TECHNICAL NOTE

Job Name: Waterfront Square, Reading
Job No: 332610561
Note No: TN004
Date: December 2024
Prepared By: Rhys Husband
Reviewed By: Chris Brice
Subject: Response to RBC Highway Comments

Reading 011 (E02003399)

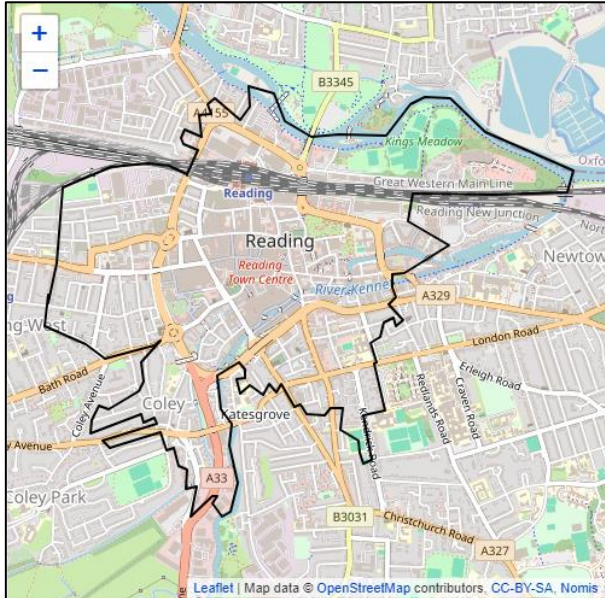
"Although the trip rates have been agreed, the Census data to identify mode share has not been agreed, given that a plan of the area assessed has not been stipulated within the application. In addition, the mode share for the office and the Class E use cannot be assessed utilizing Census data, given that this is based on the location of where residents live and not where they work. As such, this data could only be used should every employee and visitor of the existing office and proposed Class E use live within the area assessed within the Census data extent. The application must therefore be updated to provide suitable travel modes for each the office and Class E uses."

The image below displays the area where the Office mode share has been taken from Nomis for Reading 011 (E02003399).

The Highways Officer is incorrect in stating that the mode share for office and commercial cannot be assessed using Census data. There are Census datasets (WU03EW, mistakenly typed as WP03EW in the Transport Statement) that provide the mode share for those who work within an MSOA, irrespective of their home location, it provides the modes that people used to travel to employment within the destination MSOA; this was outlined in Paragraph 7.5.1 of the Transport Statement.
